Subject: MHI's Responses to US-APWR DCD RAI No. 46-215

**US-APWR Design Certification
Mitsubishi Heavy Industries
Docket No. 52-021**

RAI NO.: NO. 46-215 REVISION 0
SRP SECTION: 13.03 - EMERGENCY PLANNING
APPLICATION SECTION: 13.3
DATE OF RAI ISSUE: 7/31/2008

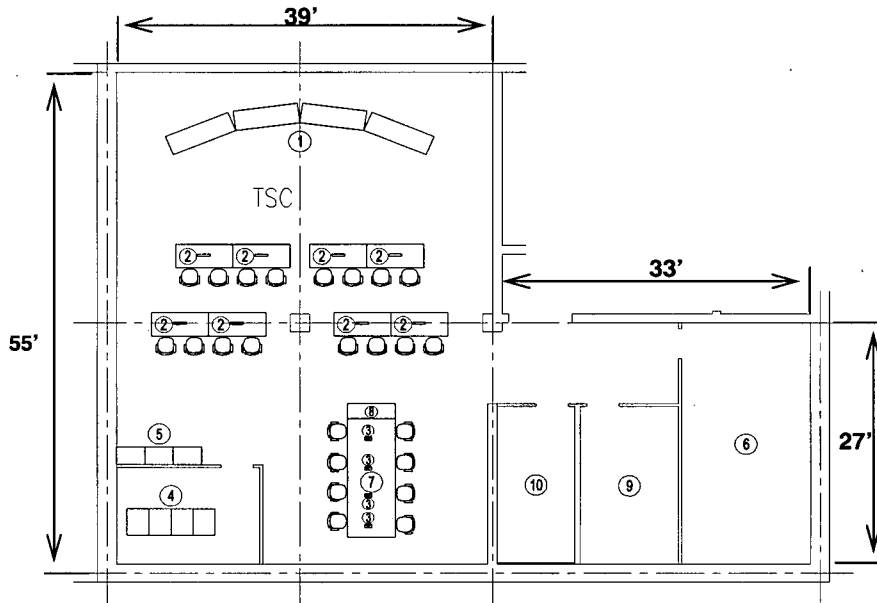
- 1) Please provide more detail as to whether the floor space of at least 1875 square feet (approximately 75 square feet for each of at least 25 personnel) as described in Sections 2.10.1, 2.10.2, 7.5.1.6.1, and 13.3 of the DCD includes the space necessary to acquire, process, repair, maintenance, and service equipment, and/or includes the storage space necessary for plant records and historical data.
 - 2) Please explain the impact, if any, this additional space requirement may have to the TSC staff working space.
-

The detail size and arrangement of the TSC is shown in the following figure. The main space of TSC is approximately 2145 square feet (39X55), which exceeds the minimum requirement of 1875 square feet. DCD Subsection 7.5.1.6.1 will be revised to explain that this space is sufficient to maintain and repair TSC equipment, and is sufficient for the storage of plant records and historical data.

In addition, the TSC includes kitchen and restroom facilities and another room for private NRC consultation. This area of the TSC is approximately 891 square feet (33X27).

Contents
1	Large Display Panel
2	Plant Monitoring VDUs
3	Communication equipments (phone, facsimiles, etc.)
4	Display Processor Data Transmitter
5	Cabinet for plant records and historical data, etc.
6	NRC consultation rooms
7	Sufficient table and chairs for staffs
8	Printers/hardcopies
9	Kitchen
10	Rest room

“Adequate working space for the personnel assigned to the TSC at the maximum level of occupancy is approximately 75 sq ft/person. The TSC working space is sized for a minimum of 25 persons, including 20 persons designated by the licensee and five NRC personnel. The TSC arrangement drawing is shown in Figure 7.5-3. **The size and layout of TSC gives necessary space to maintain and repair TSC equipment, and is sufficient for the storage of plant records and historical data.**”
